# Dixie-Narco®

## Service Bulletin #

234

- SUBJECT:
1. Sealing of the Rain Guard.
  2. Adding Water Trough above Select Switches.
  3. Sealing of the Trim.

Fig. 1

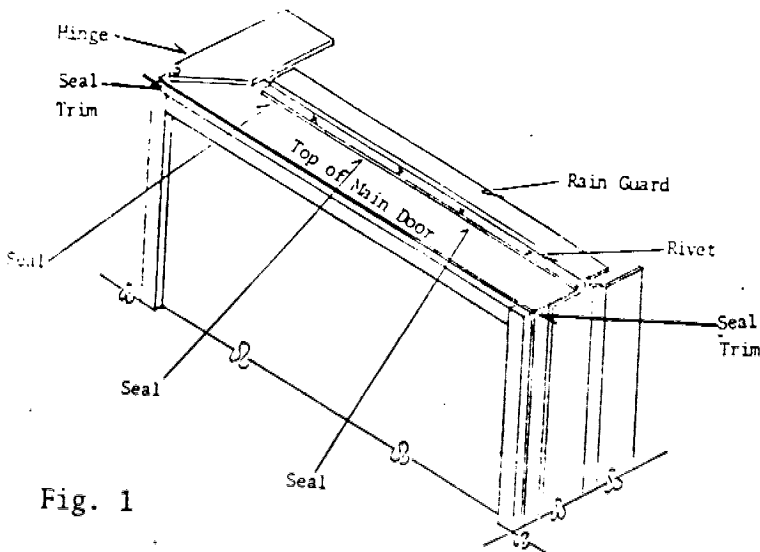
On outside locations where the INCB Vender may be subjected to heavy driving rain storms it might be possible for water to get by the Rain Guard and down in the top of the Vertical Trim - See Fig. 1.

CORRECTION: Seal along entire length at edge of Rain Guard. Seal also at each Pop Rivet. Also seal open ends at top of Vertical Trim. See Fig. 1

Fig. 2

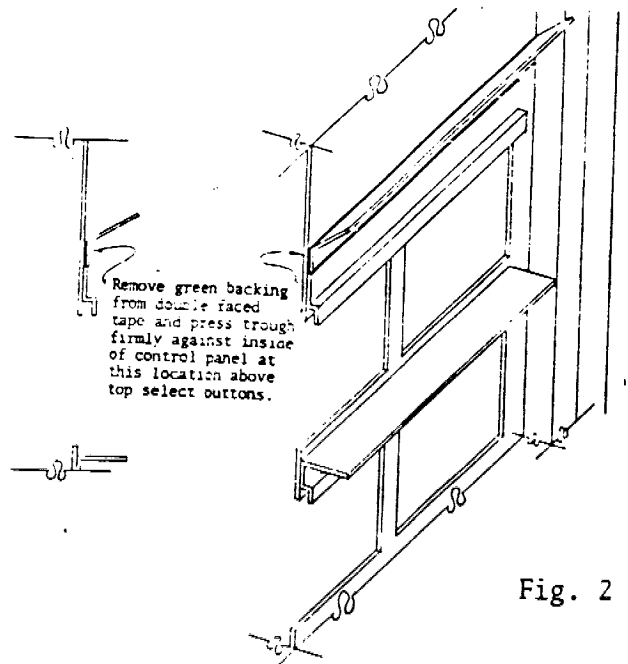
Also, water may enter coin slot. Drain teeth are provided in all coin insert castings at entrance to coin chute. This water can drain down the inside face of select panel. The trough provided will divert the water over to side, away from select switches.

See Fig. 2 for installation of trough.

CORRECTION: Remove green backing from double faced tape and press trough firmly against inside of control panel at this location above top select buttons. See Fig. 2
